## **NOTICE OF A TYPE II DECISION ON A PROPOSAL IN YOUR NEIGHBORHOOD**

### **CASE FILE NUMBER: LU 15-101868 DZ**

*WINDOW REPLACEMENT AT 1225 SW ALDER STREET*

EXH. C.2

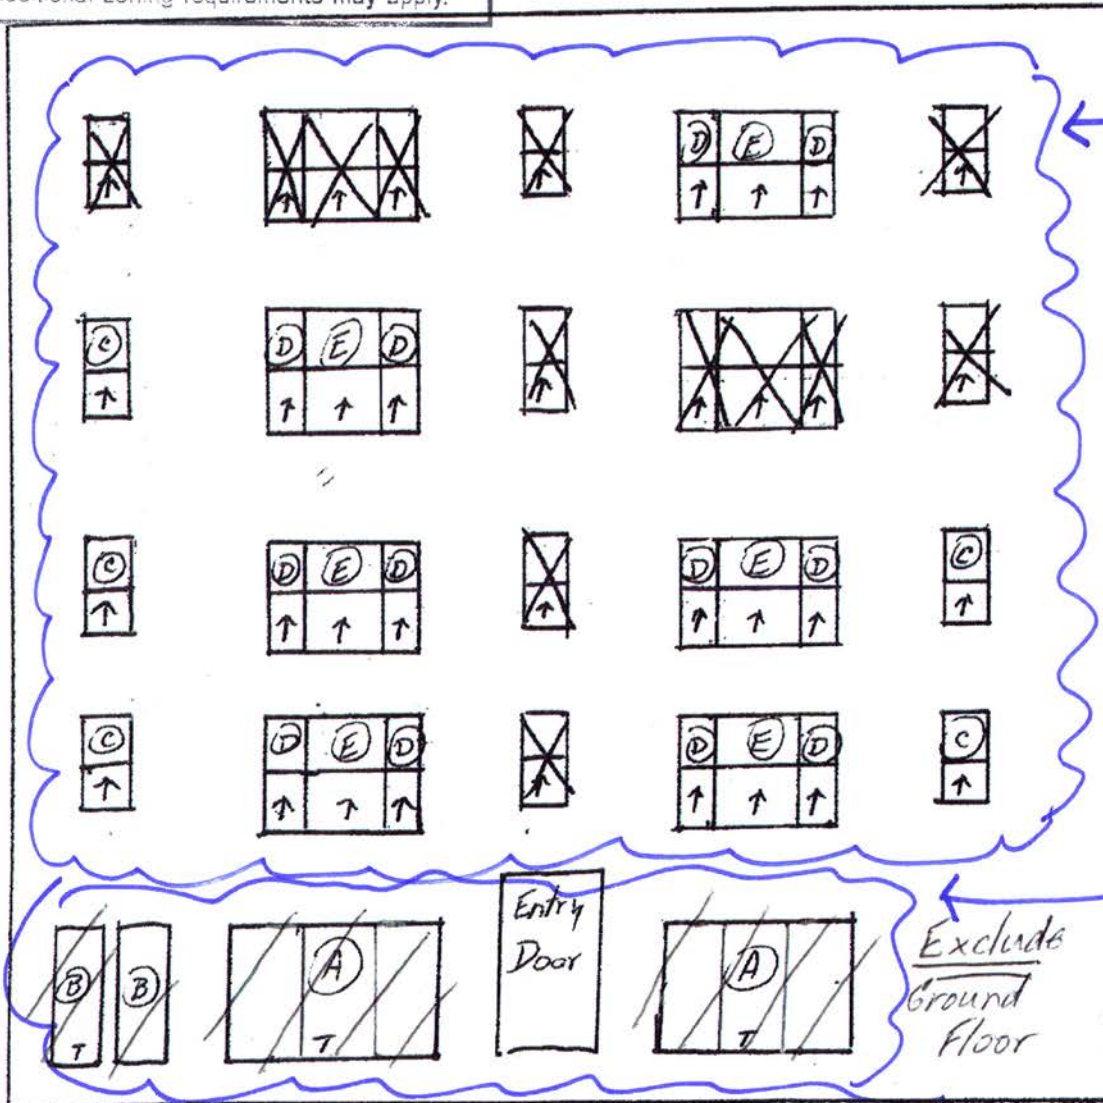
**Findings for C2, and C5:** On the south (street) elevation, windows on second through fifth floors will be replaced with windows that match the current design but are fiberglass instead of wood. The replacement windows will be located within existing openings and maintain existing brick moldings and sills, replacing existing double-hung wood windows. Marvin's Integrity All Ultrex, Single Hung windows in white are proposed. The new windows will have similar sight lines and be located in the same plan relative to the face of the building as the existing windows to maintain existing shadow lines. The proposed fiberglass windows employ a traditional style that blends well with the existing building details and decoration common to the building and other older properties in the West End Subarea of the Downtown Subdistrict of the Central City Plan District.

The applicant stated that they do not intend to replace existing previously non-approved vinyl window replacements. However, in order to maintain quality and a uniform appearance across the street elevation, as a condition of this approval, (refer to Condition B) existing non-approved vinyl windows are required to be replaced with these fiberglass windows.

Approval of new fiberglass single-hung windows to the second through fifth floors of the south façade, per the approved site plans, Exhibits C-1, C-2, C-8 and C-9, signed and dated May 18, 2015, subject to the following conditions:

EXH. C.3

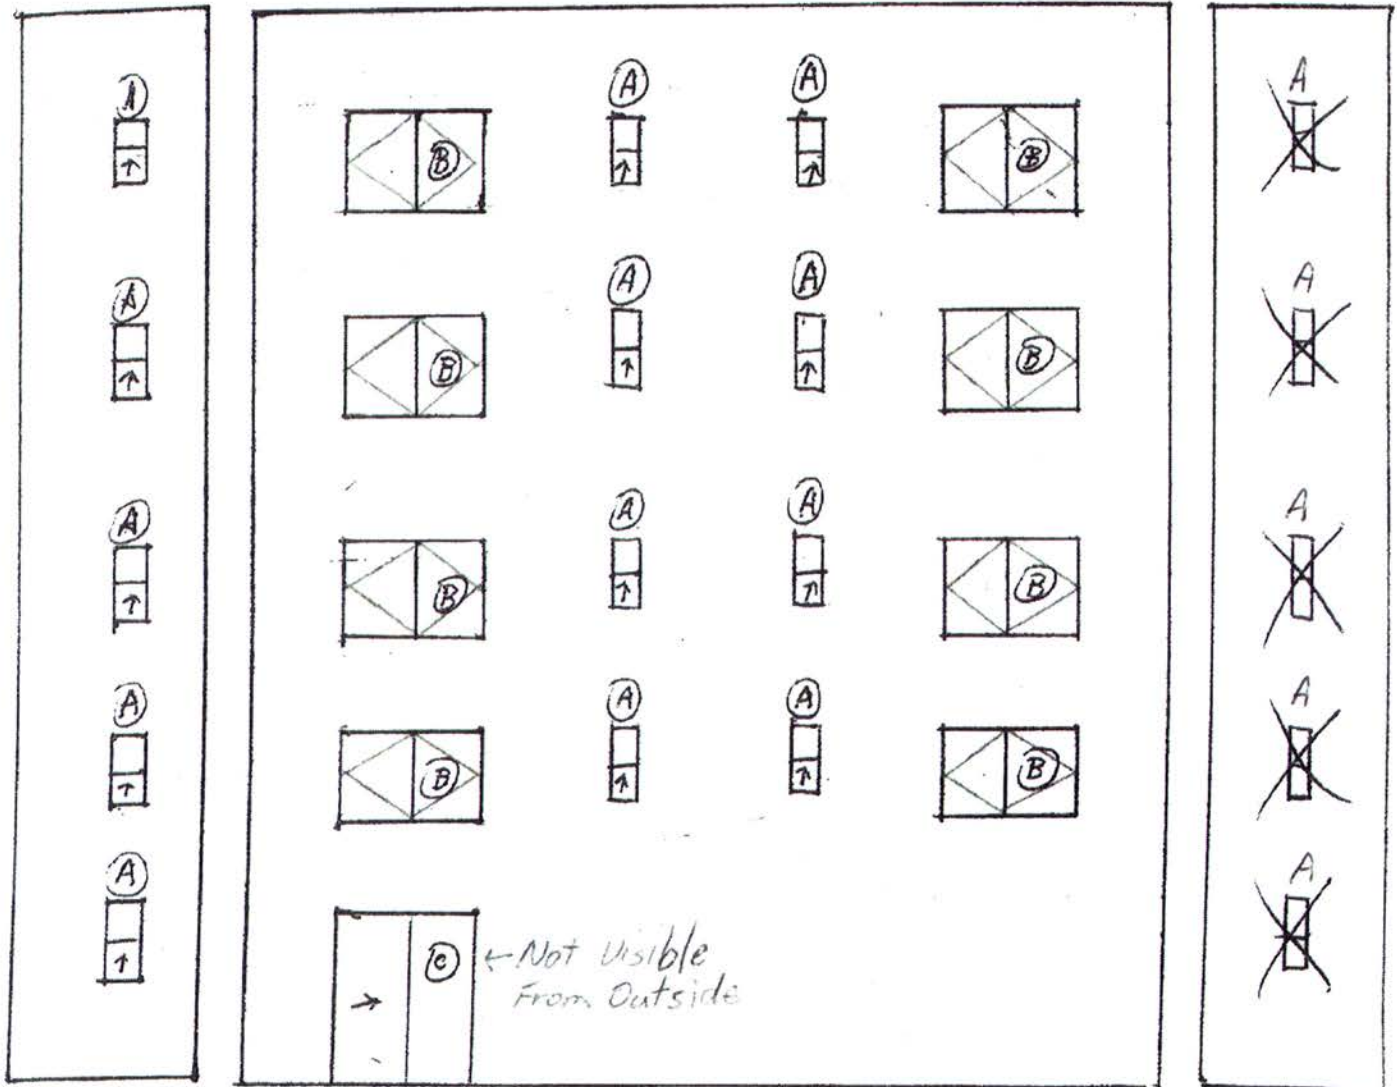
**Findings for A4, A5, A6, C3 and C4:** The early twentieth-century style of architecture of this terracotta, brick and stucco apartment building contributes to the diverse local character of this area. The vinyl replacement windows proposed to the east, west and north facade do not incorporate unifying design elements, and the proposal is inappropriate for this era of building. The new vinyl windows do not resemble the original steel windows in profile, size, style, or proportion.

Size, style and proportions of casement windows replacing 72" steel window assemblies: The new pair of vinyl casement windows proposed to replace the existing 72" steel assemblies substantially changes the look and proportion of the existing windows. Most of the existing steel windows contain an assembly of 8x4 divided-lite windows with a centered pair of 2x3 divided-lite casements. The proposal to replace the existing steel assemblies with a pair of vinyl casement windows does not maintain the historic size, style or proportions of the existing window assemblies and does not complement the historic style or the proportions of existing window assemblies.

Size, style and proportions of single-hung windows replacing 18" steel single-casement windows: The new vinyl single-hung windows proposed to replace the existing 18" divided-lite steel casements change the size, style and proportion of the existing windows. The existing steel casement windows are 2x3 divided-lite casements. The

Denial of new vinyl windows to the west, east and north façades, per Exhibits C-3, C-4, C-5, C-11, C-12, C-13, C-15, and C-16.
